SUBJECT: DISCUSSION BETWEEN TXU ELECTRIC AND THE U. S. NUCLEAR
REGULATORY COMMISSION (NRC) STAFF CONCERNING THE
COMANCHE PEAK STEAM ELECTRIC STATION (CPSES), UNIT 1,
STEAM GENERATOR TUBE INSPECTION

NRC Questions for the CPSES 1RF08 Outage Phone Call (4/4/01)

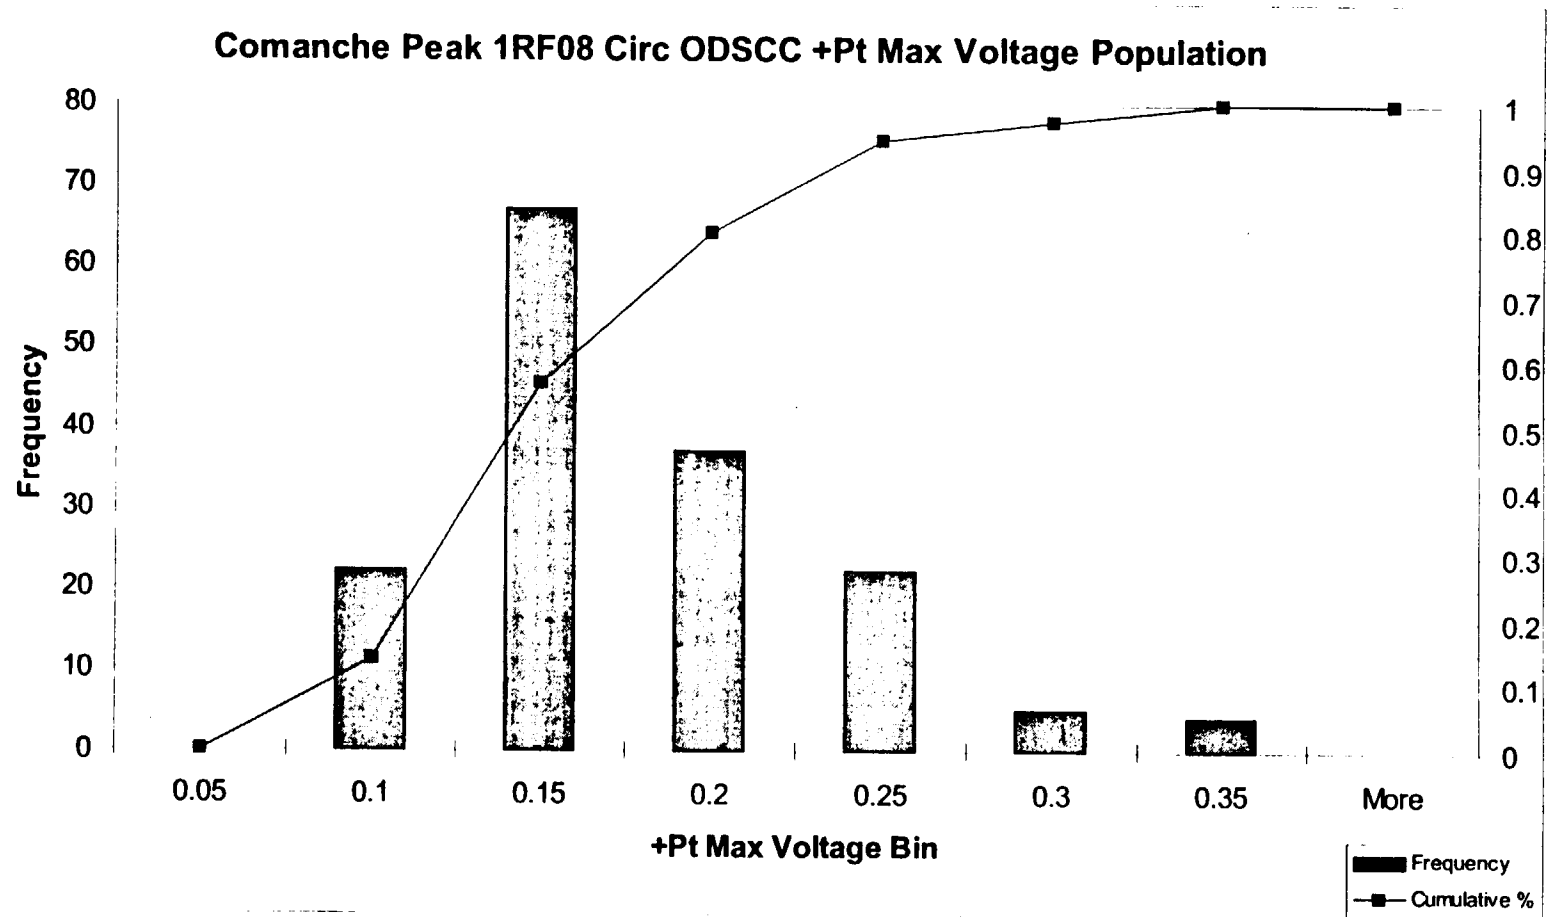
4. For analyzed EC results, describe bobbin indications (those not examined with rotating pancake coil (RPC)) and RPC/Plus Point/Cecco indications. Include the following information: location, number, degradation mode, disposition, and voltages/depths/lengths of the most significant indications?

S/G Number	Location	Damage Mechanism	Quantity
1	HTS	SCI	2
1	HTS	Loose Part Wear	2
2	HTS	SCI	37
2	C10	Loose Part Wear	3
2	HTS	SVI	2
3	HTS	SAI	2
3	HTS	SCI	69
3	C3	Preheater Wear	2
4	HTS	SCI	49
<u>Total Pluggable Indications</u>			(168)

**Mid-Range vs High Freq Noise Values: Tube by Tube Comparison
90° Analysis Window at Extrados, Intrados, and Flanks**

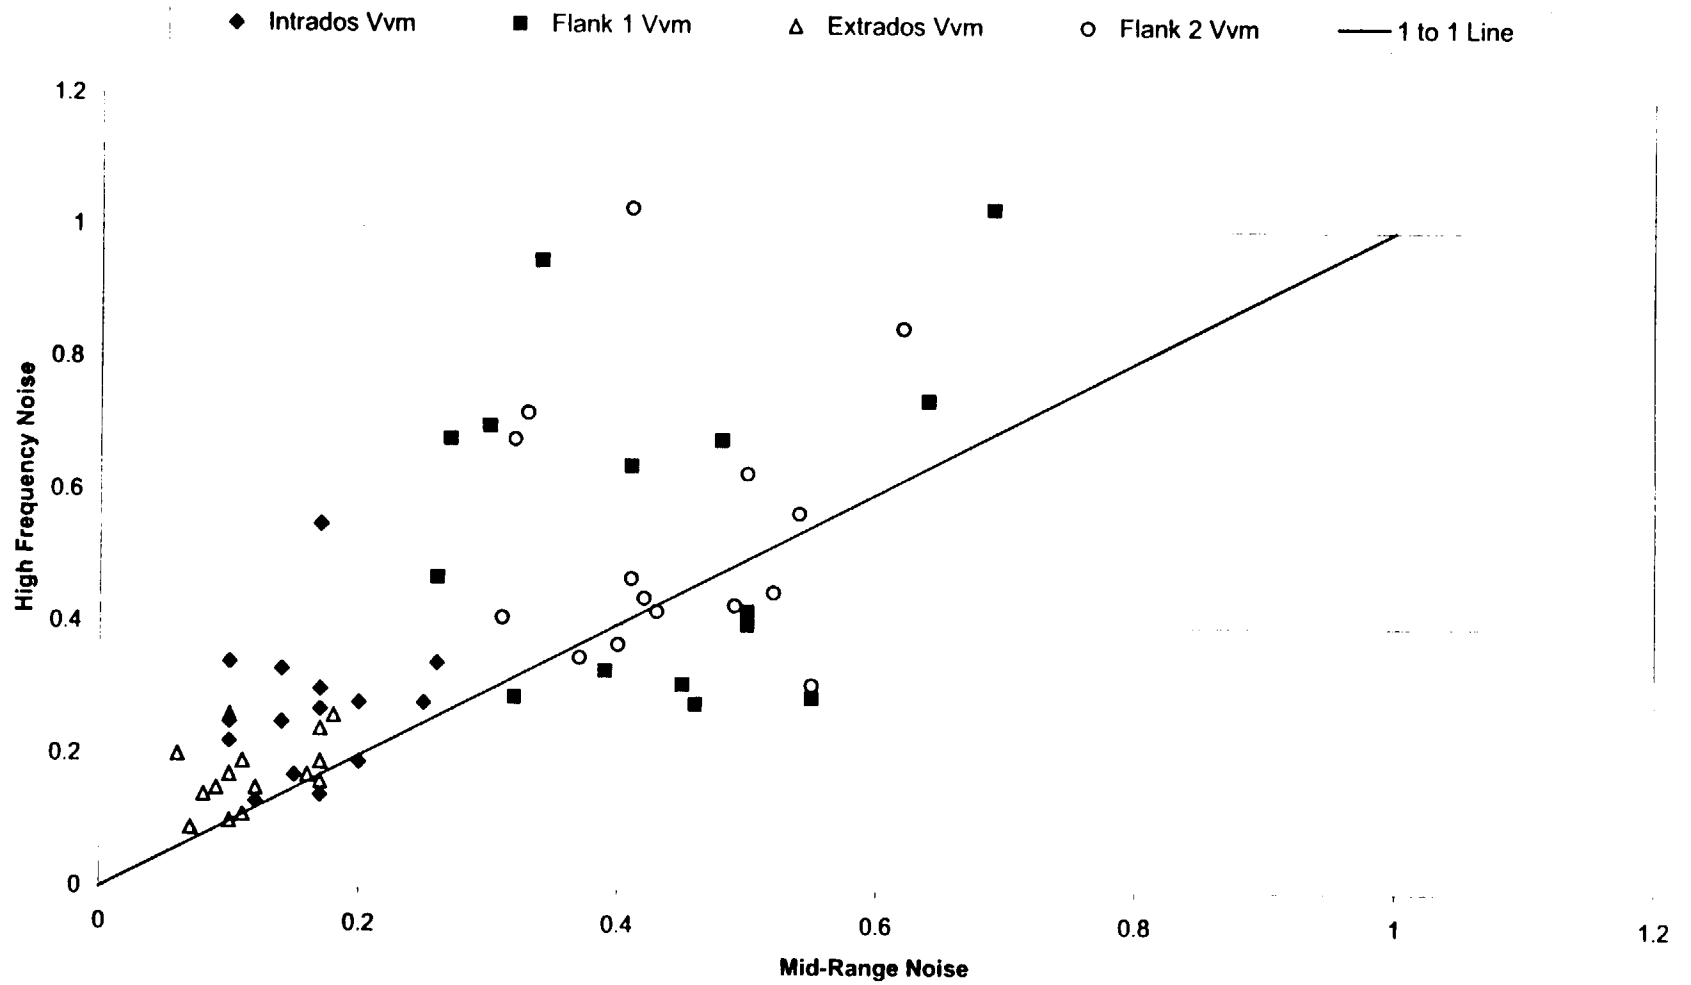
- b) the actions taken to ensure that data noise levels are acceptable

Noise levels were evaluated prior to the outage using guidance developed by Westinghouse. This evaluation concluded that some high frequency +Pt examination should be conducted. The plant average peak to peak and vertical maximum values were slightly higher than the ETSS 96511 data. At 95% confidence, the plant data was slightly less than the ETSS 96511 data. The high frequency examinations were performed on those tubes with the largest noise components, up to a sampling level of 20%. For the conditions specific to Comanche Peak 1, the high frequency +Pt is not expected to produce a condition where PWSCC detection in the U-bend region is increased. This is based on the negligible OD deposit condition at CPSES 1, due to chemical cleaning at 1RF05 and application of scale conditioning agents at each outage. Further evaluation shows that for the area of the tubes most likely to develop PWSCC, namely the extrados region, the noise levels are substantially low that adequate detection capabilities are provided using the mid-range +Pt. For

the 1RF08 inspection, noise levels are slightly reduced compared to the 1RF07 data. Evaluation of high frequency +PT noise levels indicates that vertical maximum noise levels are increased for the high frequency coil compared to the mid-range.
